City of Corpus Christi

Planning Commission

Wednesday, April 6, 2022

**TECHNICAL REVIEW PLAT REQUIREMENTS
REGULAR PLANNING COMMISSION MEETING
April 6, 2022**

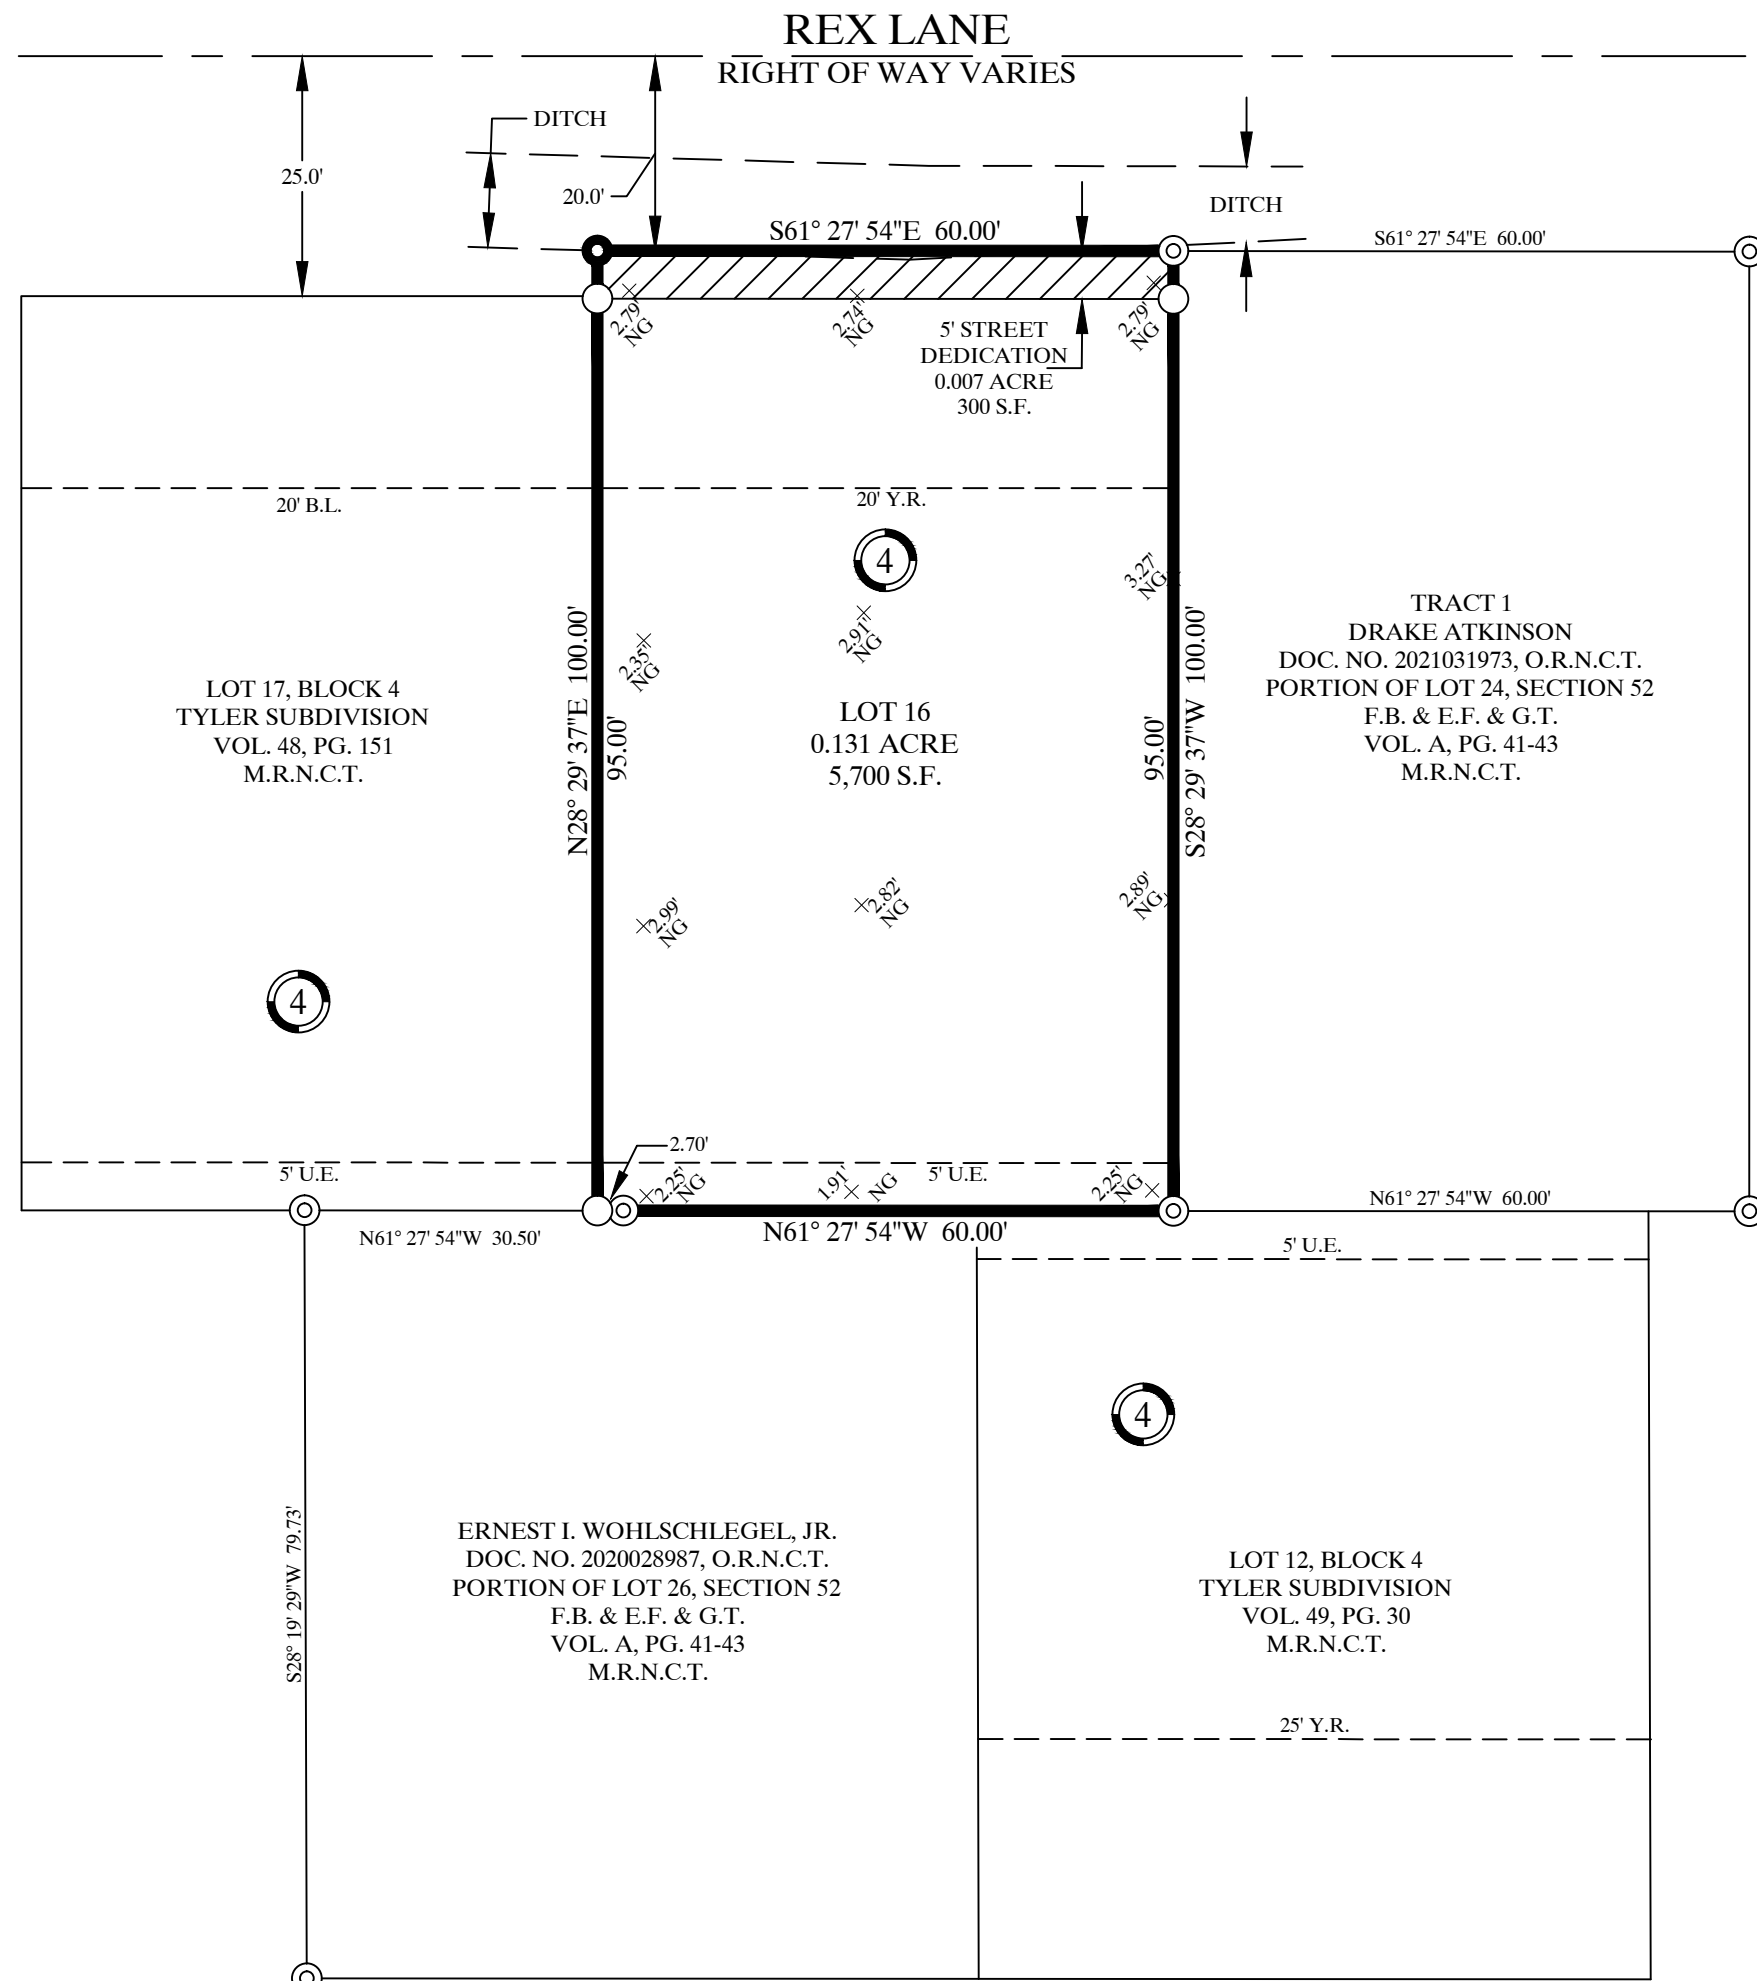
LAND DEVELOPMENT						
No.	Sheet	Comment	Applicant Response	Staff Resolution	Applicant Response	Staff Resolution
1	Plat	Replace "Final Plat of" with "Plat of" in plat's title.	CHANGED HEADER.	Addressed.		
2	Plat	Remove final from the plat description.	CHANGER VERBAGE.	Addressed.		
3	Plat	Remove site number from ROW label.	REMOVED SITE NUMBER.	Addressed.		
4	Plat	Remove S in acres where acreage is below 2.	REMOVED S's.	Addressed.		
	Plat	Label other tract owned by applicant with legal description. Include owner's name as well. Do the same for Portion Lot 26, Section 52.	UPDATED ADJOINER INFO.	Addressed.		
6	Plat	Update Planning Commission certificate block to "...WAS APPROVED BY THE PLANNING COMMISSION ON BEHALF OF THE CITY OF CORPUS CHRISTI, TEXAS."	CHANGED CERTIFICATE BLOCK.	Addressed.		
7	Plat	Daniel Dibble is new Chairman for Planning Commission. Update the Planning Commission certificate block accordingly.	UPDATED CHAIRMAN NAME.	Addressed.

8	Plat	If applicable, provide a vendor's lien certificate block.	N/A	Addressed.		
9	Plat	Show/label any ditch.	SHOWING AND LABELED DITCH.	Addressed.		
10	Plat	Water Distribution System Lot Fee: 1 Lot x (\$200.20/Lot)= \$200.20	OK.			
11	Plat	Wastewater System Lot Fee: 1 Lot x (\$432.30/Lot)= \$432.30	OK.			
12	Plat	Water Pro-Rata Fee: 60 LF x (\$11.58/LF) = \$694.80	OK.			
13	Plat	Wastewater Pro-Rata Fee: 60 LF x (\$13.40/LF) = \$804.00	OK.

CORPUS CHRISTI INTERNATIONAL AIRPORT						
No.	Sheet	Comment	Applicant Response	Staff Resolution	Applicant Response	Staff Resolution
1	Plat	1.4 miles South of Waldron ALF. This property has been identified as being located within the navigable airspace of Waldron ALF. (The following general note shall be included on the plat...) "The property owner shall be responsible for ensuring that any proposed constructions or alterations occurring on said property will comply with 14 CFR, §77 (Title 14, Part 77), Federal Regulations. The property owner shall ensure all development is within all Land Compatibility Use (Title 14, Part 150) Federal Regulations."	ADDED TO NOTE 8.	Addressed.

Plat of
South Texas Bone and Joint Medical Plaza
Unit 1
Block 1, Lots 2A and 2B

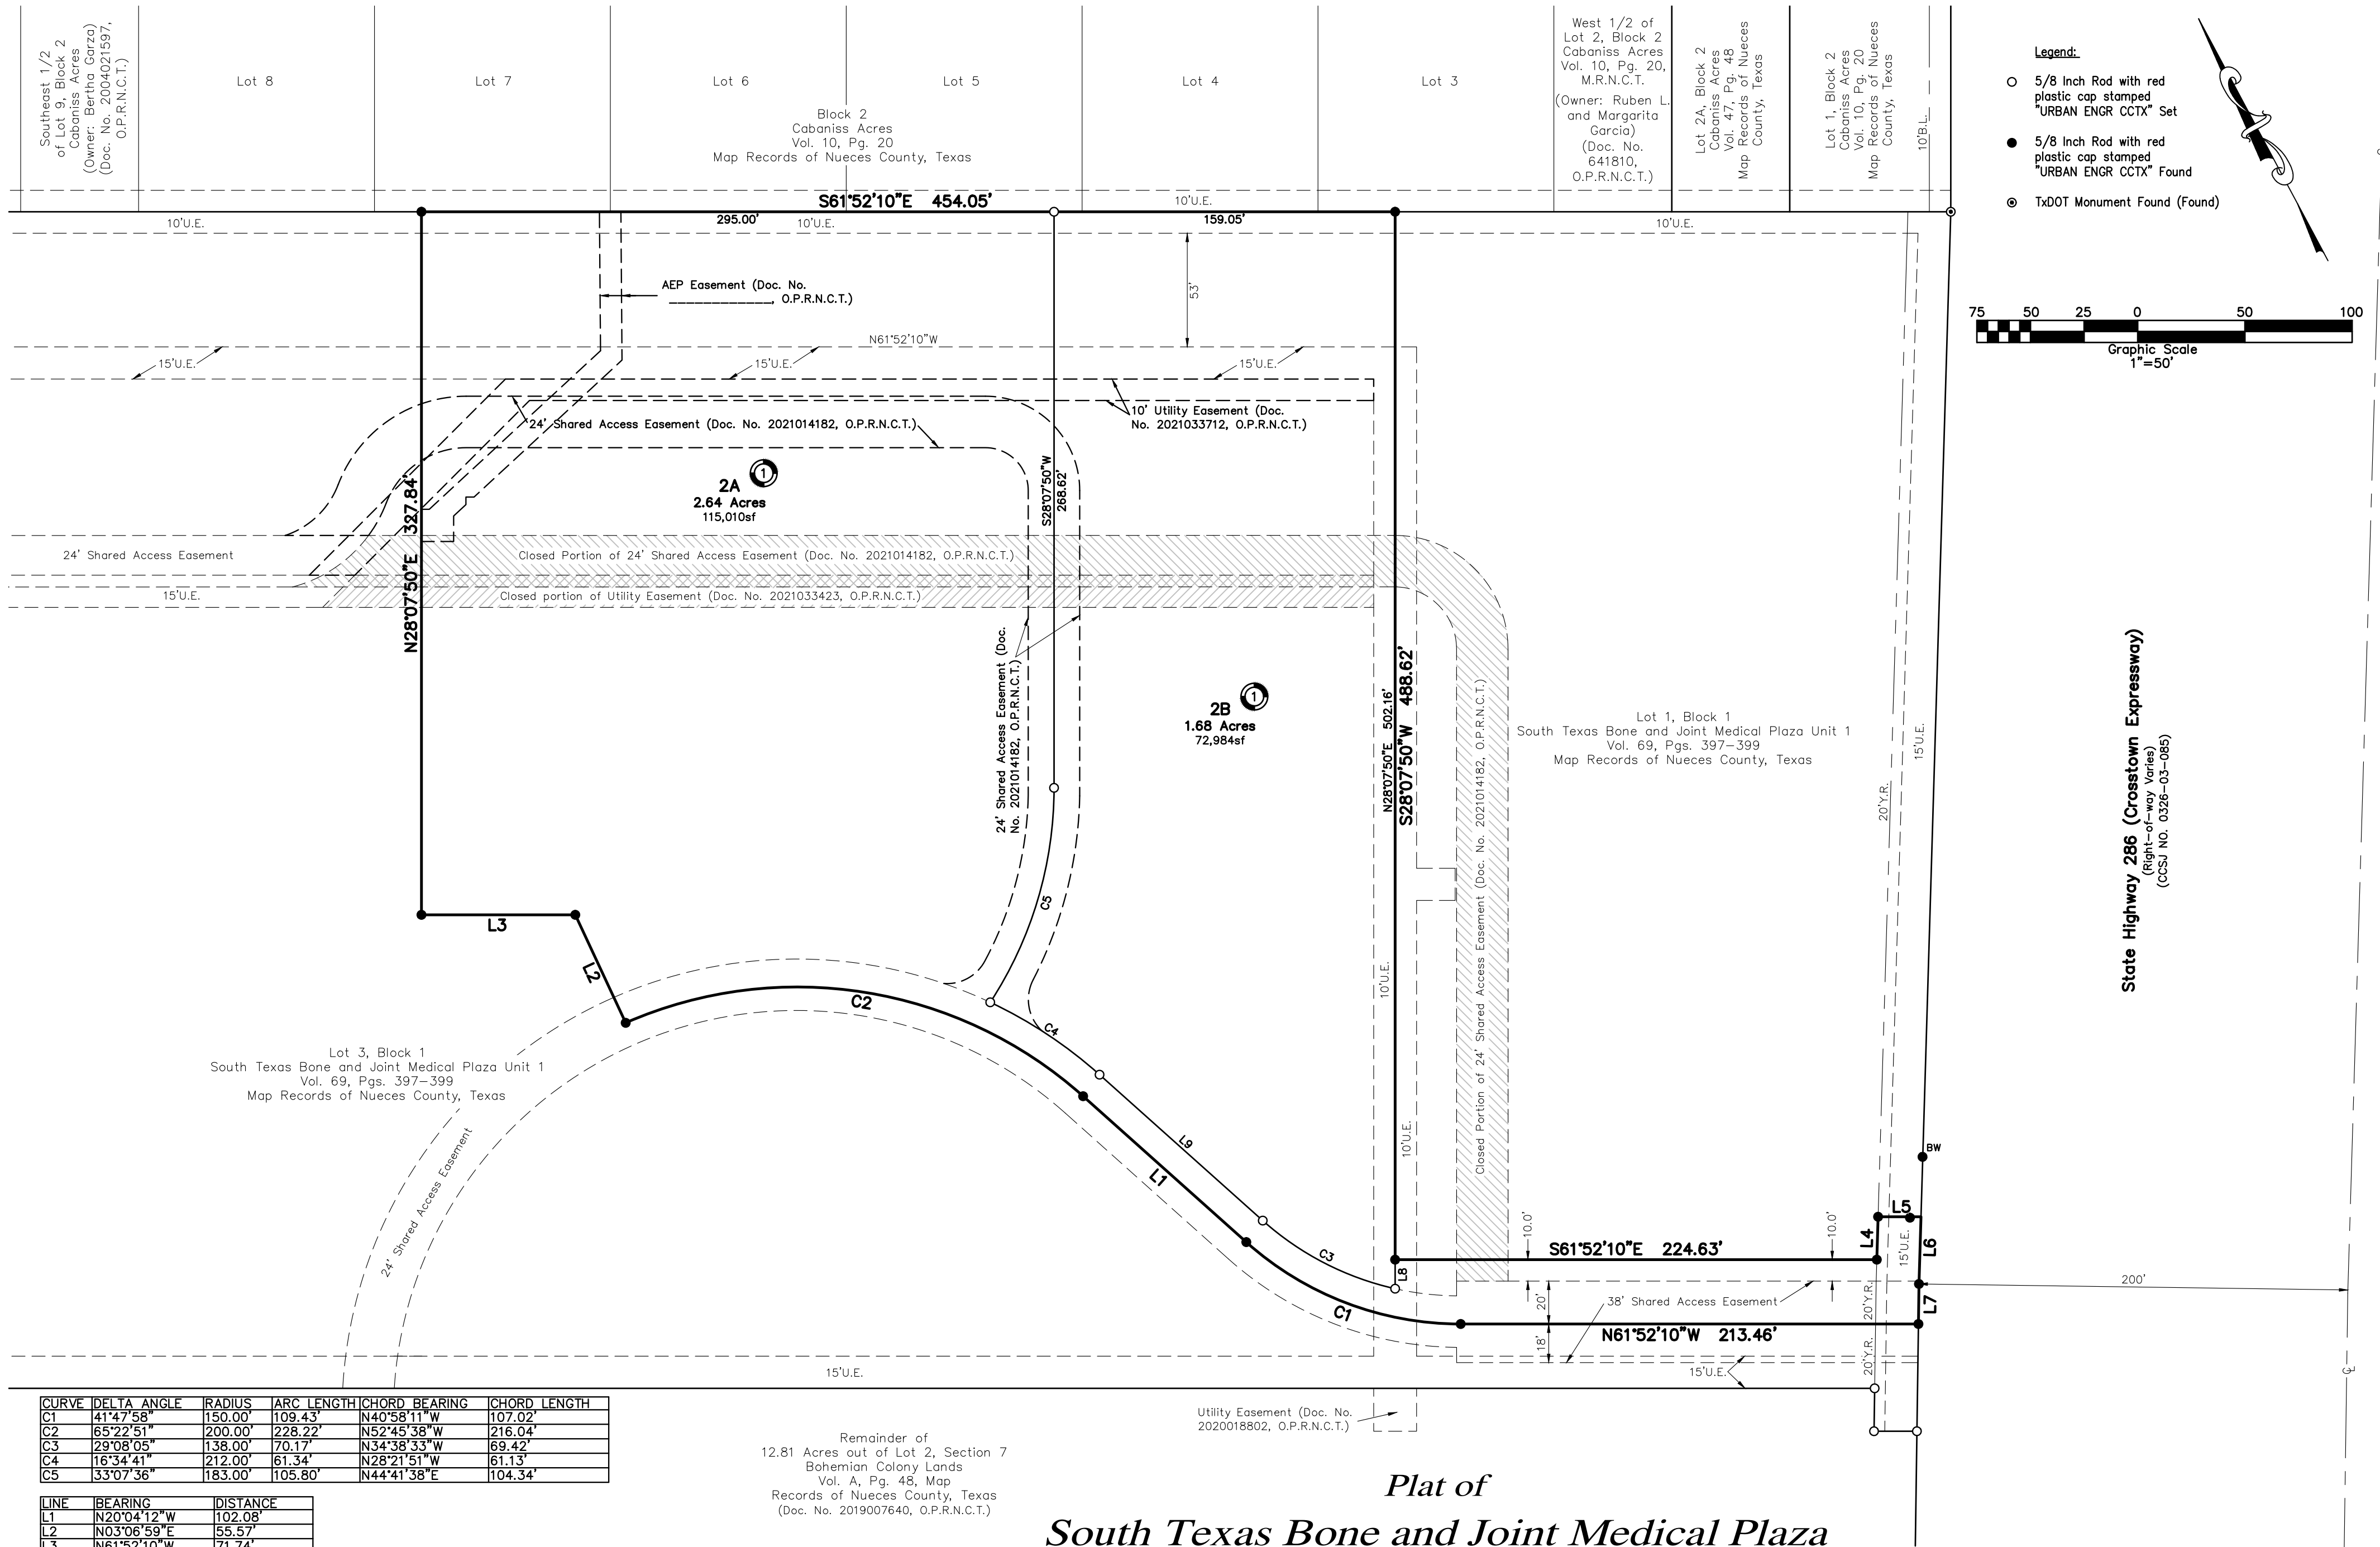
LAND DEVELOPMENT						
No.	Sheet	Comment	Applicant Response	Staff Resolution	Applicant Response	Staff Resolution
1	Plat	Change "Bing a minor re-plat" to read as "Being a Replat of"	has been revised	Resolved		
2	Plat	Replace "Director of the development services" to " Planning commission" in the signature block.	has been revised	Resolved		
3	Plat	Revise signature to " Al Raymond, III, AIA , Secretary"	has been revised	Resolved		
4	Plat	Document number missing for AEP Easement labelled.	Understood, will be added prior to recordation	Resolved		
5	Plat	Add signature to read as "Daniel Dibble, Chairman"	has been revised	Resolved		
6	Infor	Water and wastewater distribution fees previously paid thus, Exempt.	Understood	Resolved

1	Plat	Provide a clarification on the property dedicated to Martin half street from Dorado to Los Encinos School. Will the developer build the half street, curb and sidewalk.	No, this plat does not border Martin St.	Resolved		
2	Plat	Provide a clarification on the property dedicated to Martin half street from Los Encinos School to the end of the property. Will the developer build the half street and sidewalk?	Please see above response	Resolved		
3	Infor:	Driveways on Texas Department of Transportation (TxDOT) maintained roadways shall conform to TxDOT Design criteria and shall be permitted by TxDOT.	Understood	Resolved		
4	Informati onal:	Proposed driveway access to a public City Street shall conform to access management standards outlined in Article 7 of the UDC (UDC 7.1.7)	Understood	Resolved

No.	Sheet	Comment	Applicant Response	Staff Resolution	Applicant Response	Staff Resolution
1	Plat	Cabaniss – Westside 138kV runs through parcel in Phase 3. Our comments would be no above ground site improvements within 40’ from centerline.	Understood	Resolved
